**TOWN OF WINTER PARK
PLANNING COMMISSION**
Tuesday, January 9, 2024 8:00 AM

TO Planning Commission
FROM Hugh Bell, Planner
THROUGH James Shockey, AICP, Community Development Director
DATE January 9, 2024
RE Minor Site Plan – 148 Fir Drive – Lots 7 and 8, Winter Park Village Subdivision (PLN23-111)

1
A0.2

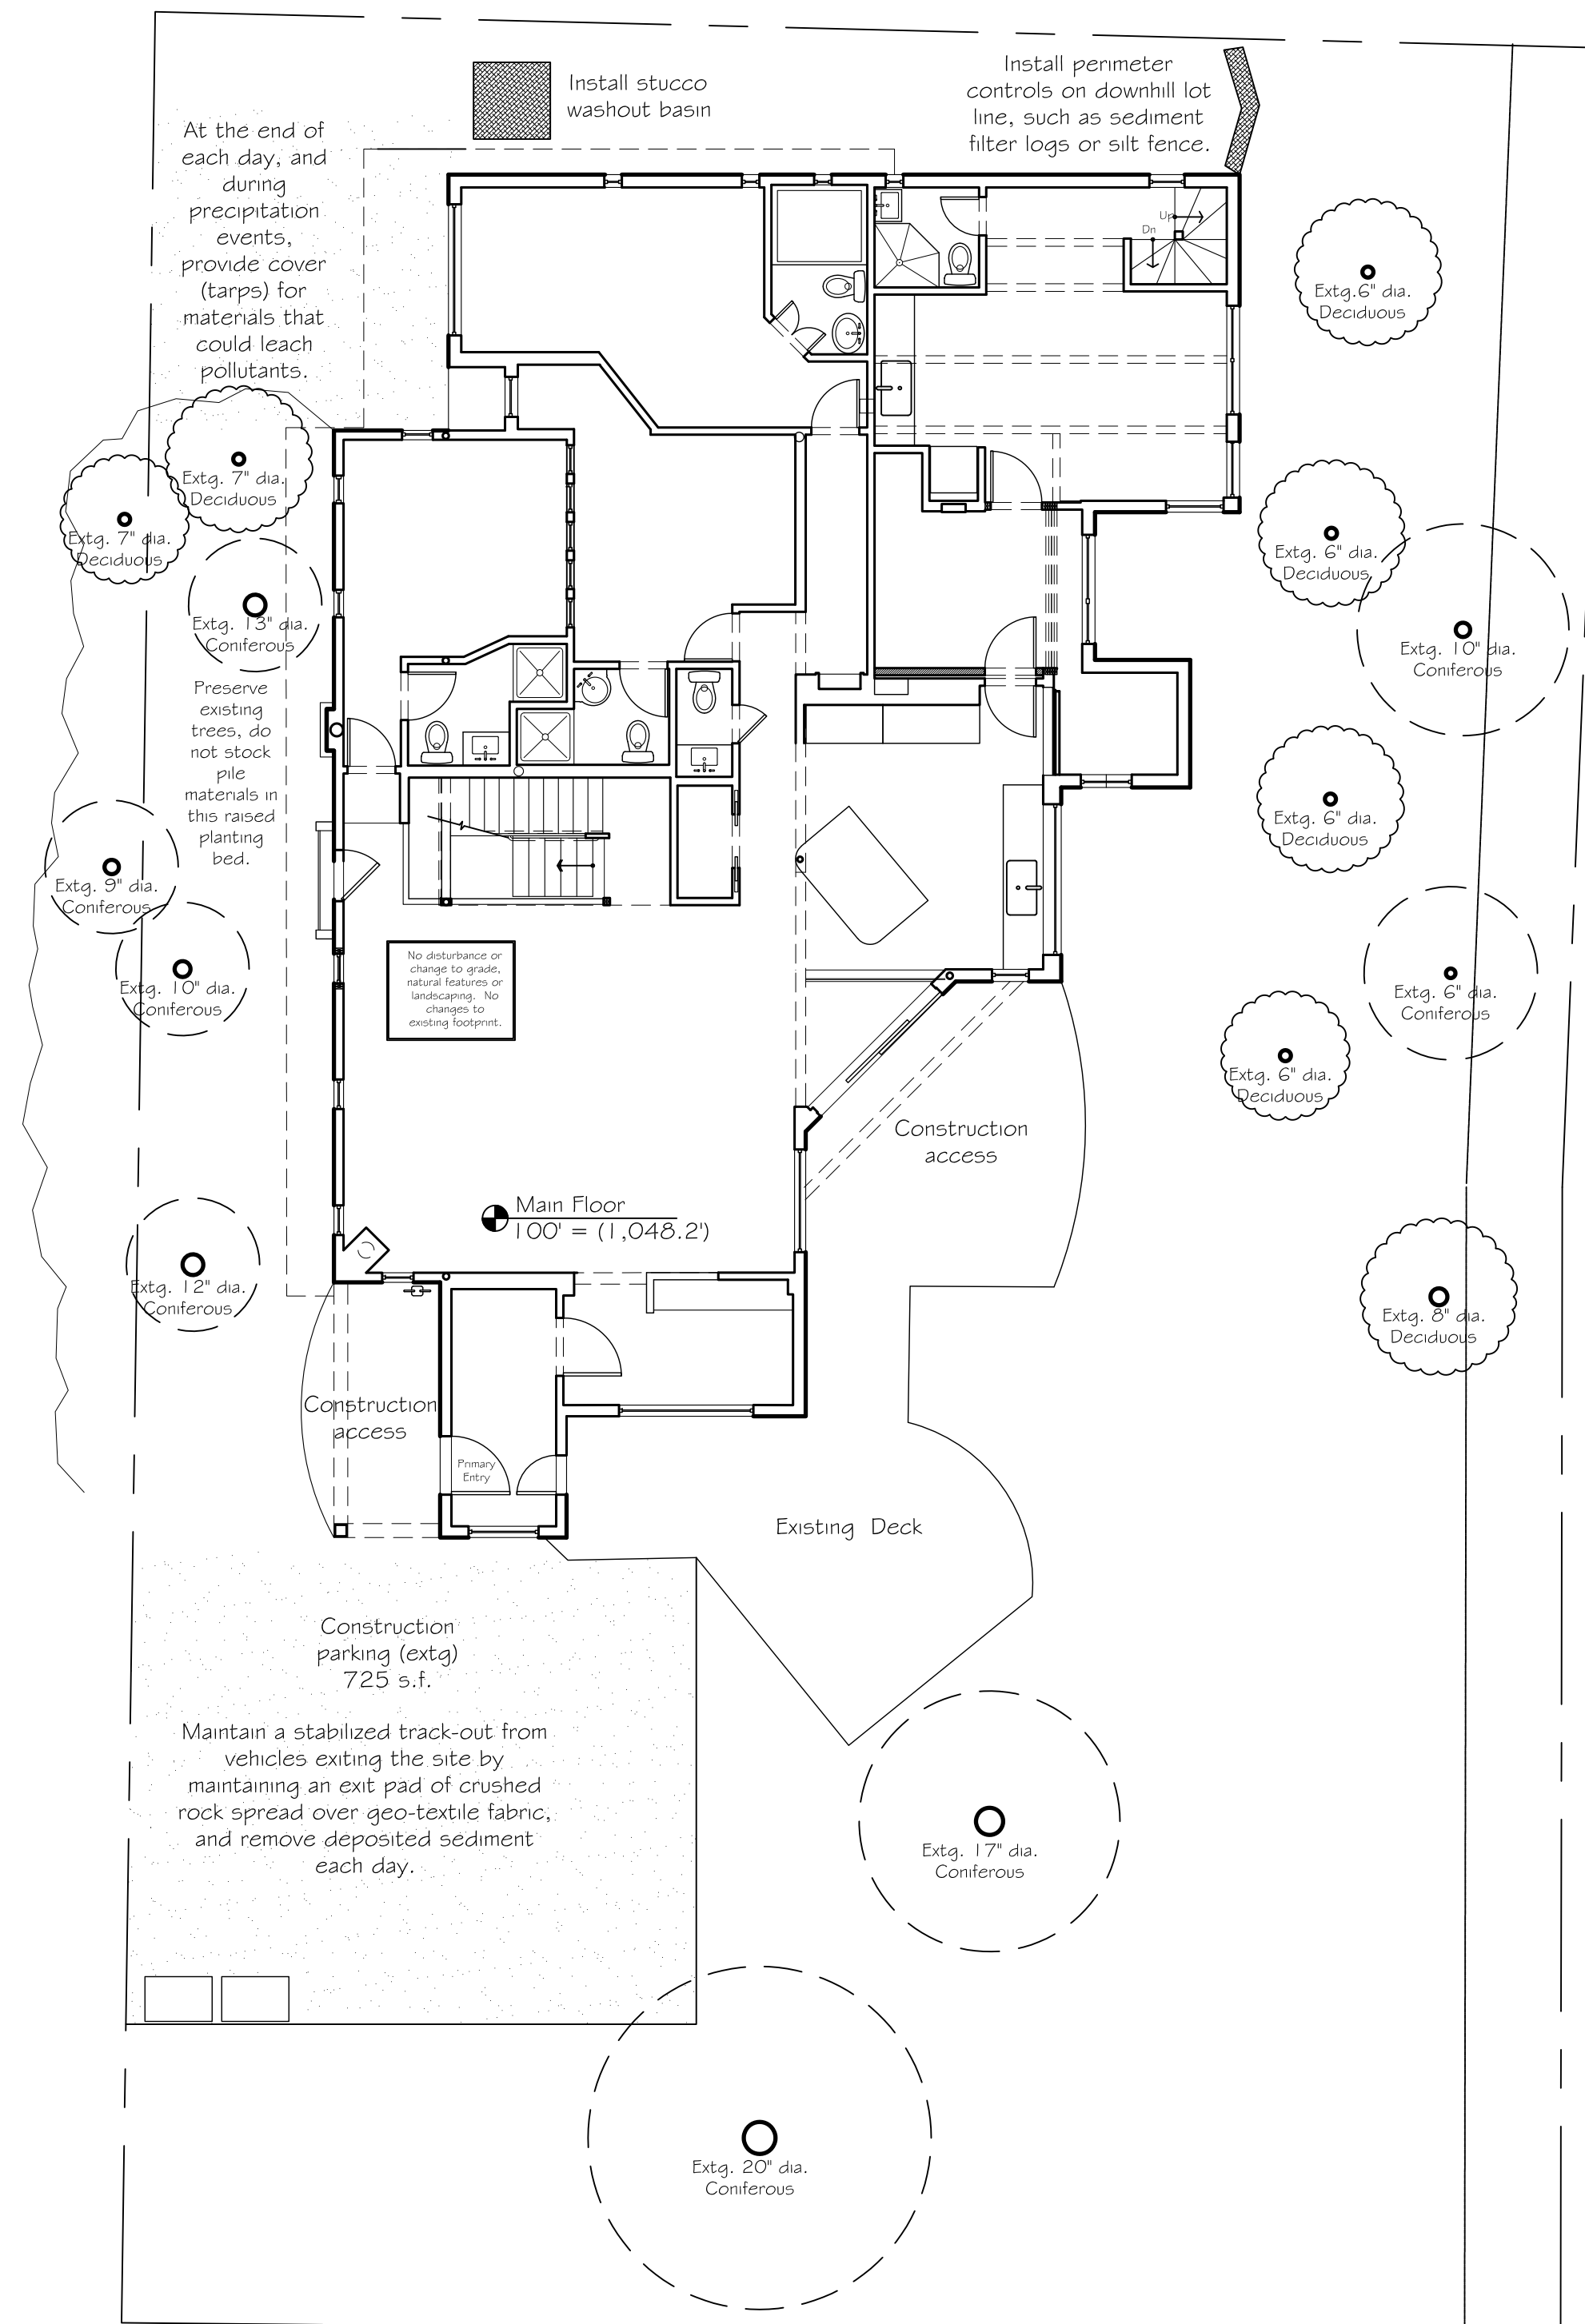
Unsatisfactory. 140 sqft. of snow storage are provided and 246 sqft are required. UDC, § 3-H-5, *Parking Design Standards* requires that a minimum of 25% of all driving surfaces, including gravel shoulders,

parking areas, and pedestrian walkways is designated for snow storage. The driveway and walkways comprise 982 sqft.

Unsatisfactory. Two (2) driveways are contemplated and both are currently gravel. Section 4.6, Surfacing, in the Standards requires all driveways be paved. Paving these will not cause building coverage to exceed that permitted. Additionally, slope is not indicated. Section 4.4, Alignment, in the Standards limits the first 24' of driveways to a 5% slope. Only one driveway is permitted per SFD DU so the north gravel area shall not reference parking.

- Applicant shall increase snow storage area to meet 25% area requirement of 246 sqft minimum.

- All site plan exhibits shall delete references to parking in the north gravel area.
- The driveway shall be paved.
- The slope shall be indicated for both driveways as a percentage.
- A stabilized construction entrance shall be installed prior to ground disturbance.

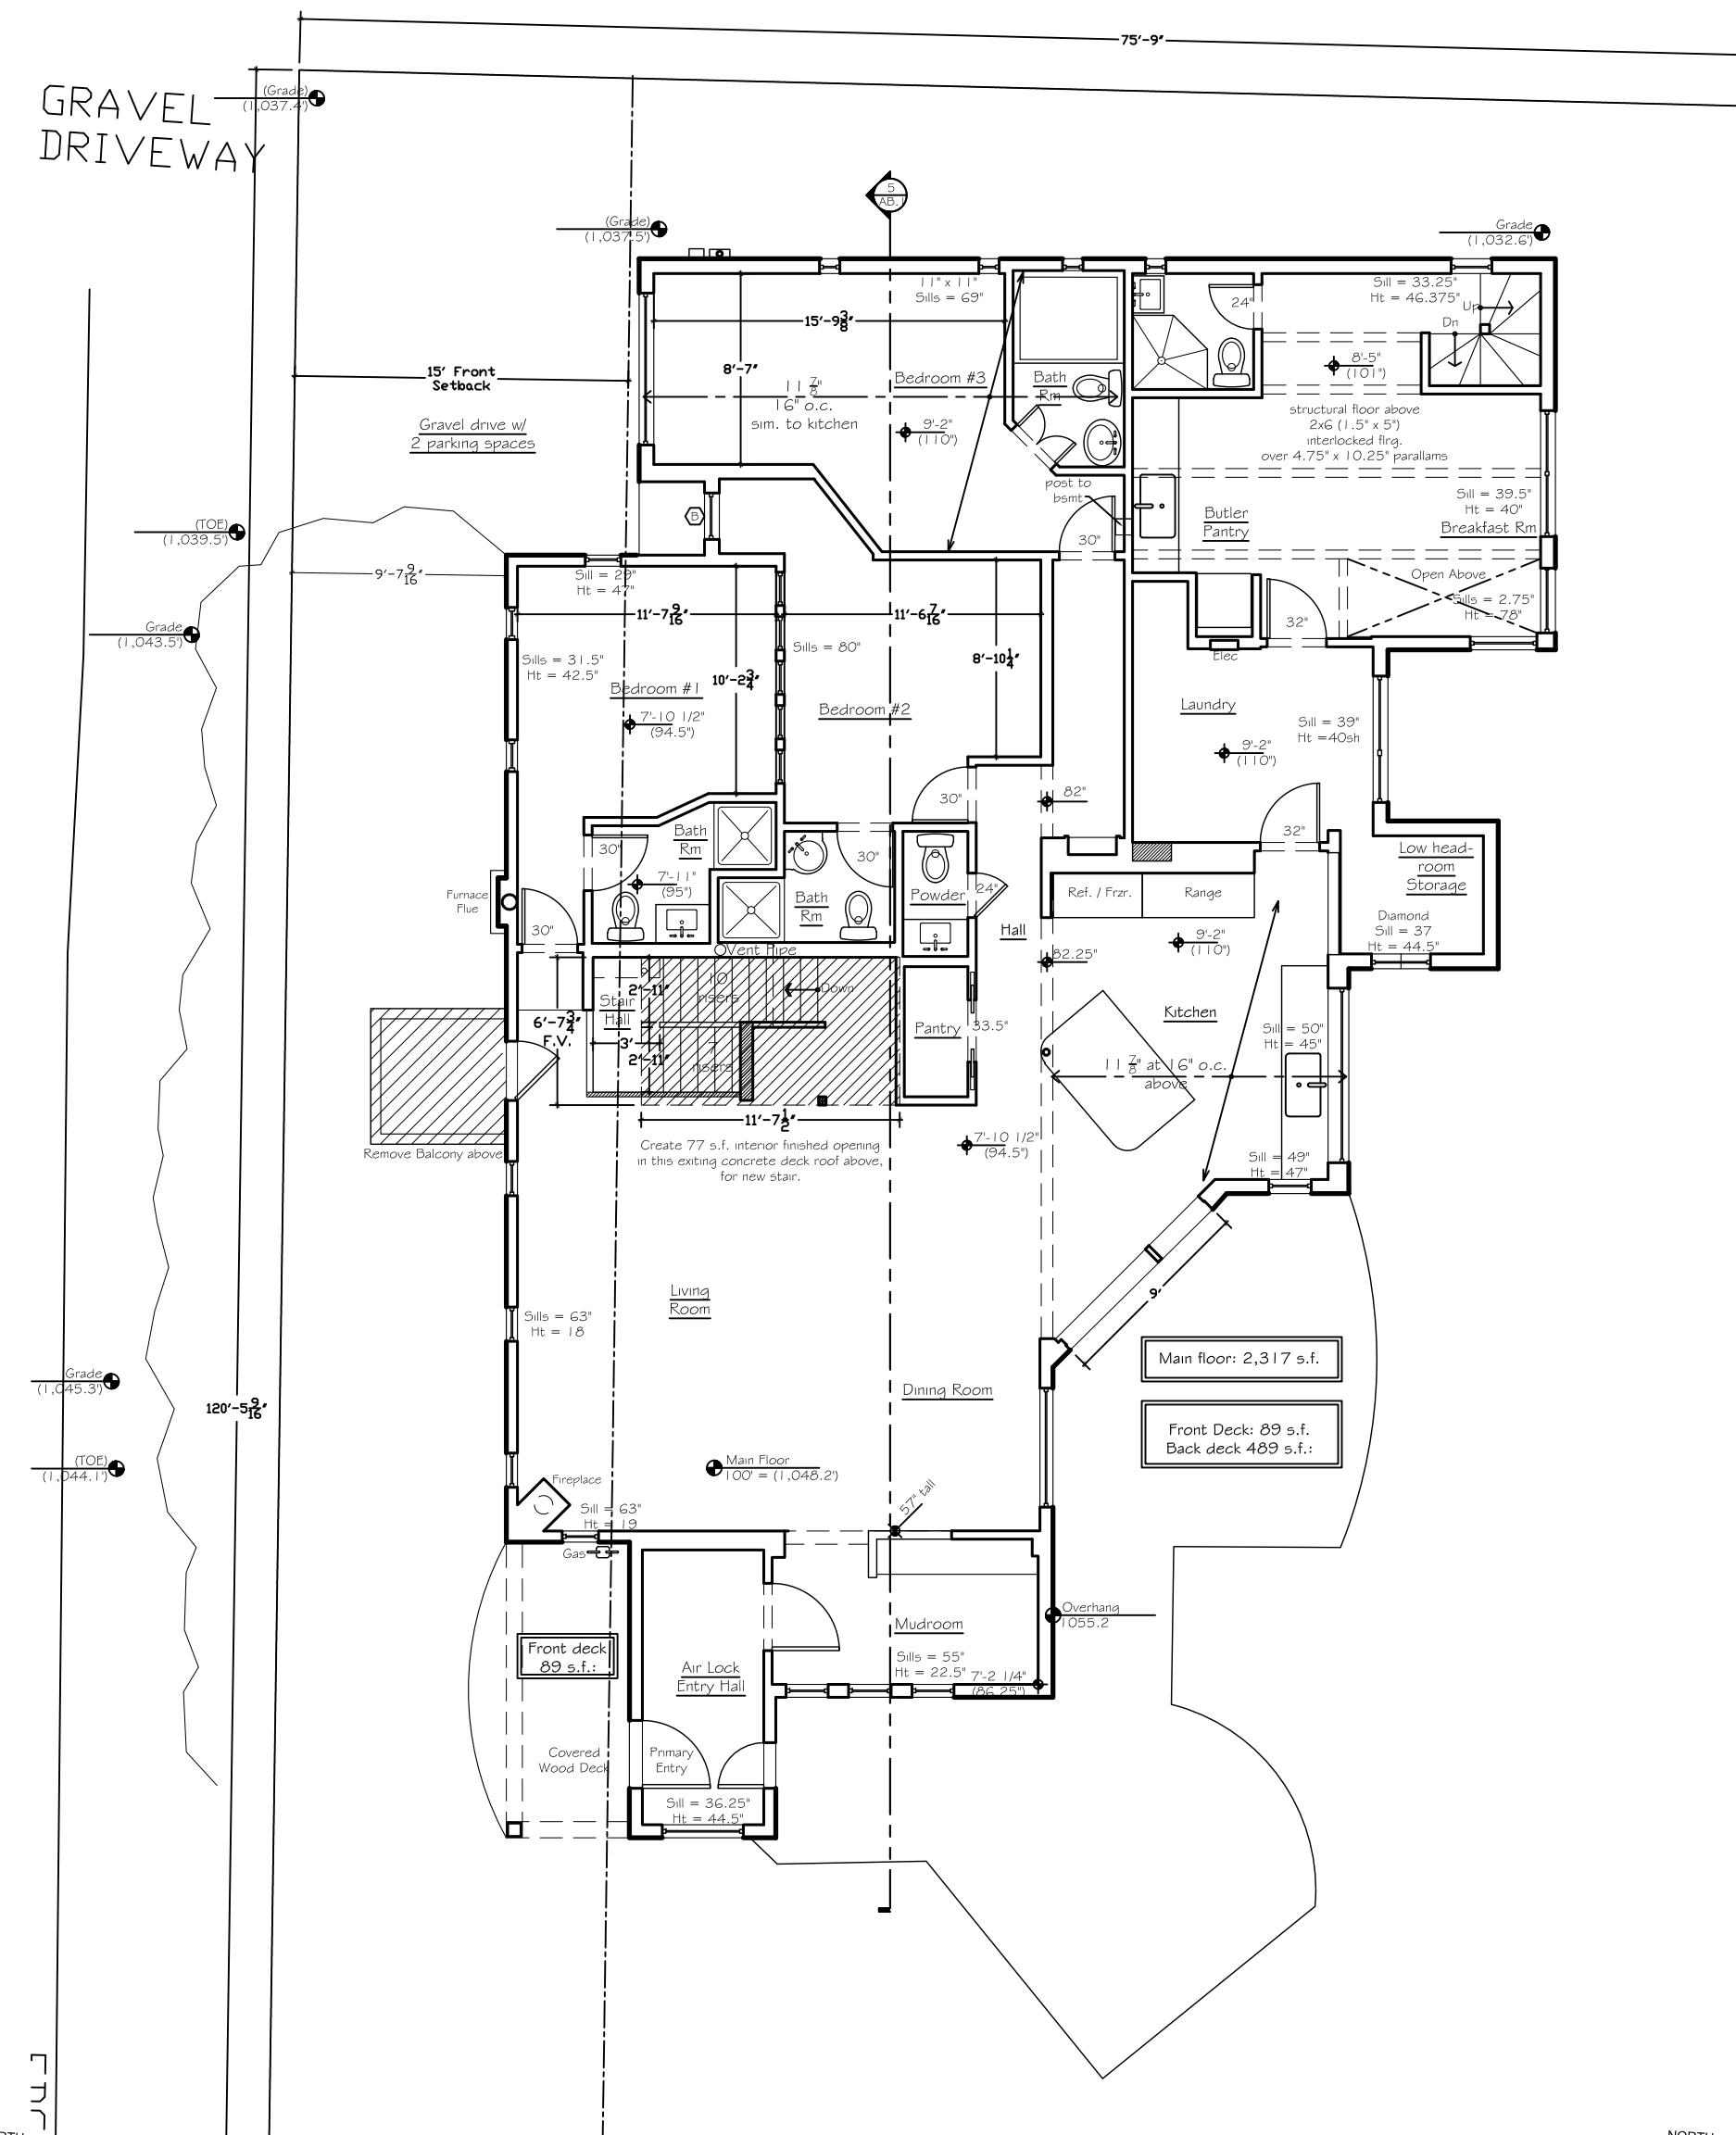
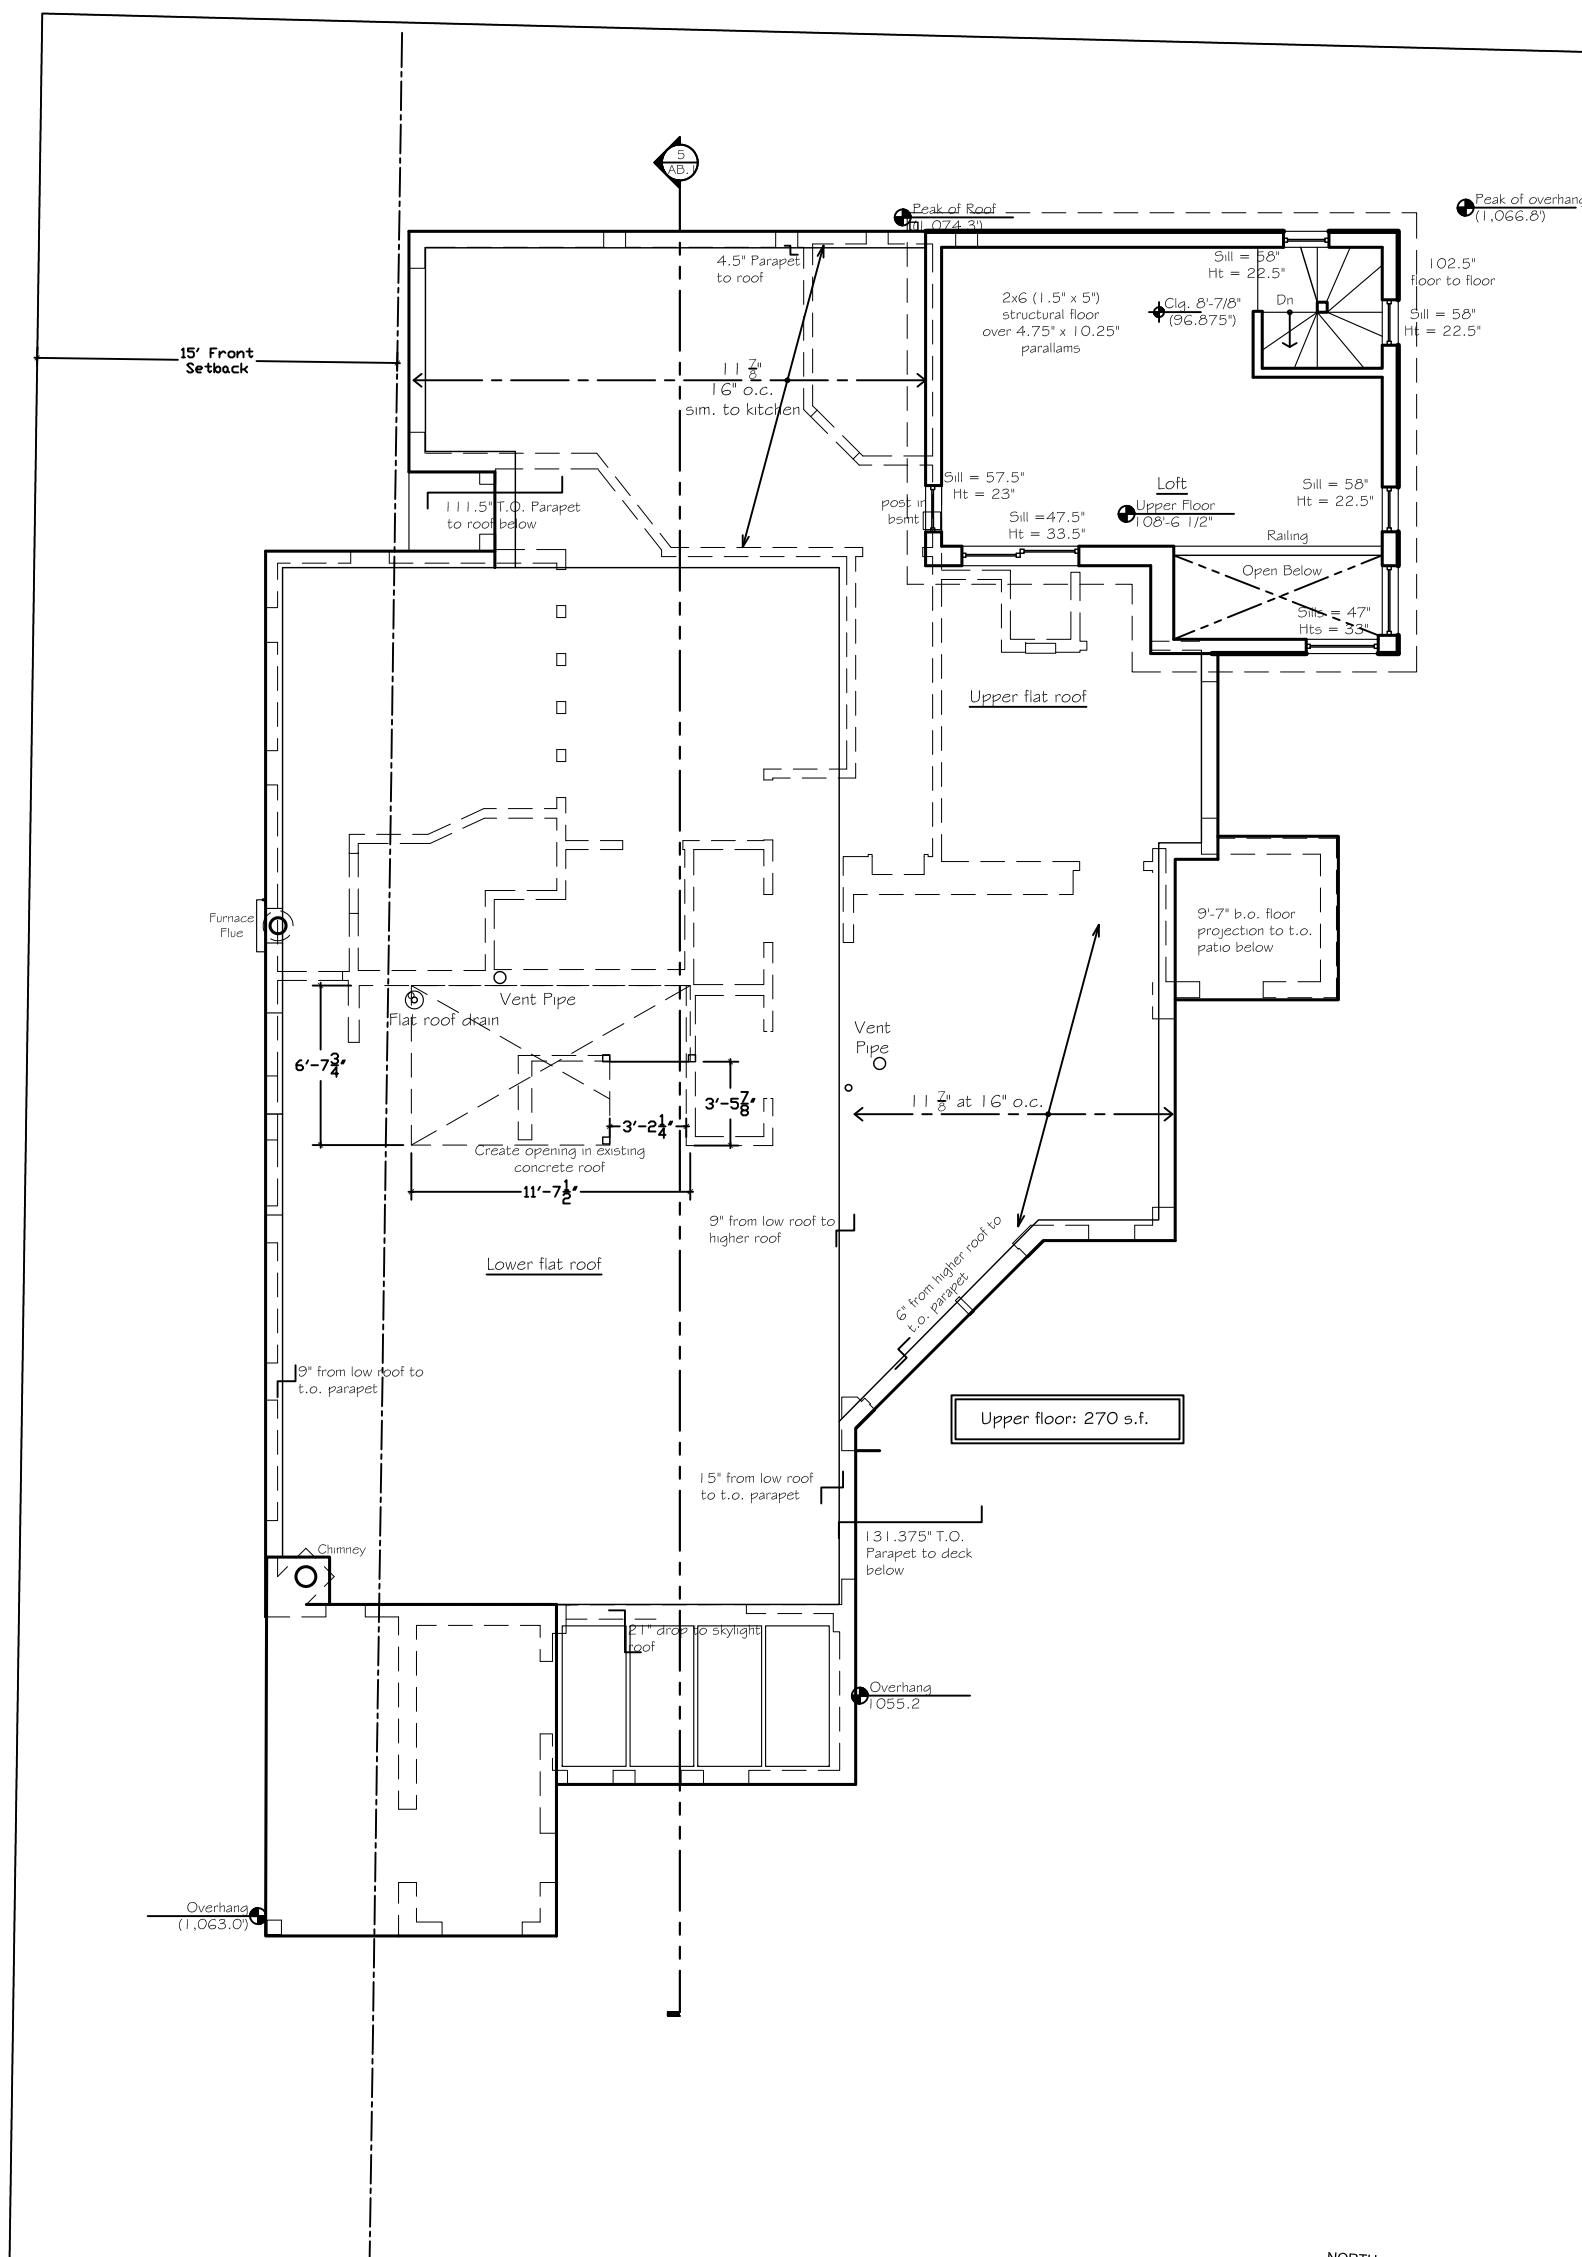
Partially satisfactory. Two (2) kitchens appear to be proposed, one existing and one new. Because the Applicant does not intend to add an ADU, they must delete the range in the new kitchen so it is not a full kitchen. See "Accessory Dwelling Unit" section above.

2. Applicant shall delete the range in the proposed kitchen so there is only one full kitchen in the house.
3. All site plan exhibits shall delete references to parking in the north gravel area.
